P40103 - RFI Response - Kardinia House, 1 Riverview Terrace, Belmont (H0337)

This letter has been prepared in response to a Request for Further Information (RFI) issued by Heritage Victoria (HV) on 23 January 2025. The RFI relates to an active permit application (P40103) for Kardinia House, 1 Riverview Terrace, Belmont (Geelong), VHR H0337. An extension was granted for the RFI response, which is due 24 March 2025.

Figure 2: Zoomed in extracts of the above images. The fences are indicated in red, and line of screening trees is shown in green. The current extent of the site aligns roughly with the eastern fence / red line. Source: State Library Victoria, edited by Trethowan Architecture.

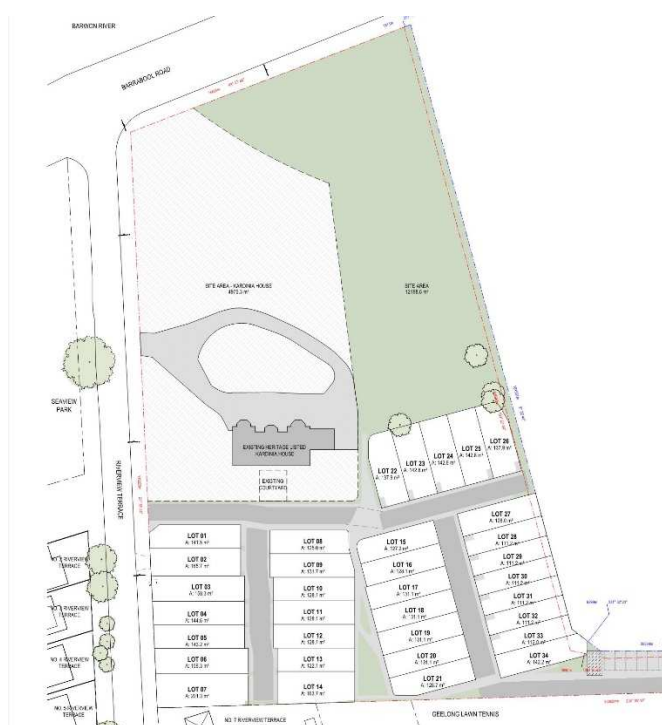
2. *A response to the comments regarding subdivision boundaries, including updated proposed plans of subdivision and drawings should changes be made. This should include, but not be limited to:*
 - a. *Discussion related to how the proposed subdivision boundaries have been determined in response to the cultural heritage significance of the registered place.*

The proposed subdivision boundary at the north of the site has been realigned in response to feedback from HV and further review of historical evidence. Aerial photography from the 1920s corroborates documentary recordings that the place included a range of landscape types at the northern area between the house and the river. Photographs (Figure 1) show a clearly that the house was separated from the river by an avenue of trees following the former driveway running east-west, with additional trees clustered at the northwest. The area in front of the house was a productive landscape with evidence of division, by fences, into different uses. The floodplain area had, therefore, an agriculturally function that is no longer evident at the place.

The proposed subdivision has been revised and is aligned in accordance with the former north-south fence line evident in the 1920s photos (Figure 2). The screening trees aligned with the circular driveway and northwest corner of the site are not proposed to be reinstated. However, this line is interpreted through the subdivision line angling towards the west at the northern part of the site (Figure 3).

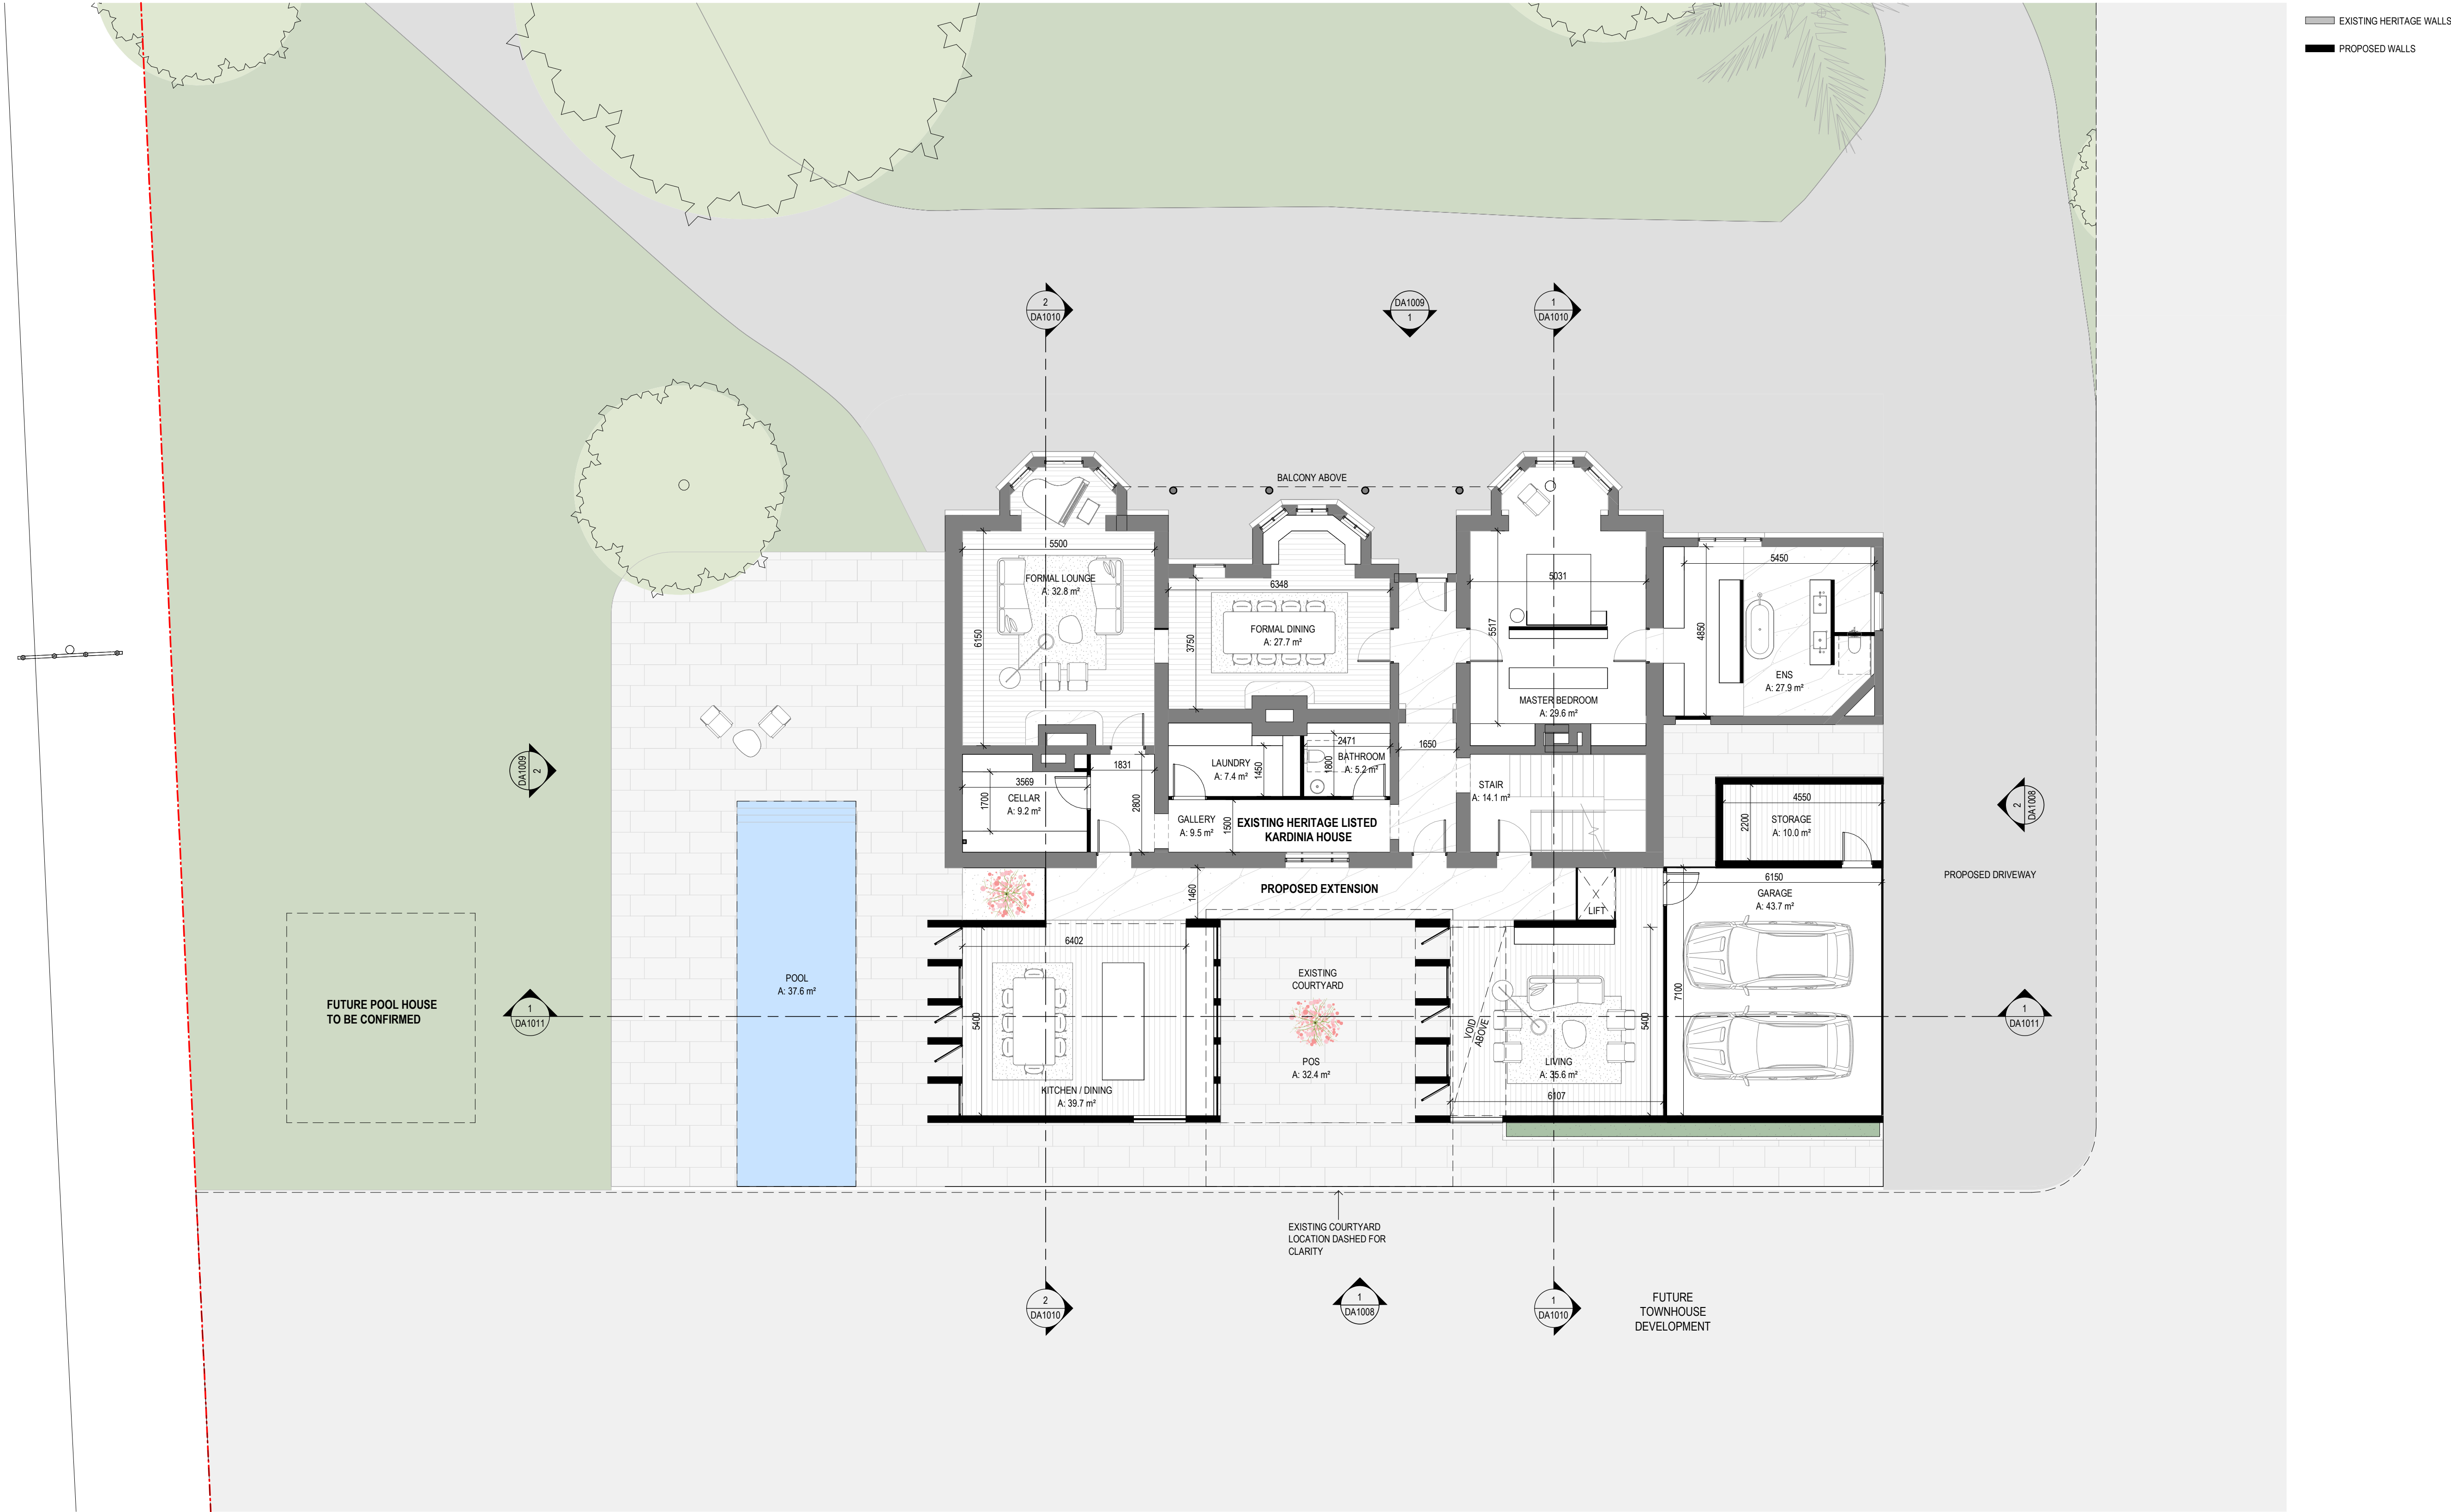
7. *A response as to why alterations and additions to Kardinia House to support its return to a private residence are not proposed as part of this application. Alternatively you may wish to add this to the application.*

Alterations and additions to Kardinia House have been added to this permit application. Please refer to updated architectural drawings, prepared by Plus Architecture and Amended Heritage Impact Statement, prepared by Trethowan Architecture, included as part of this response.
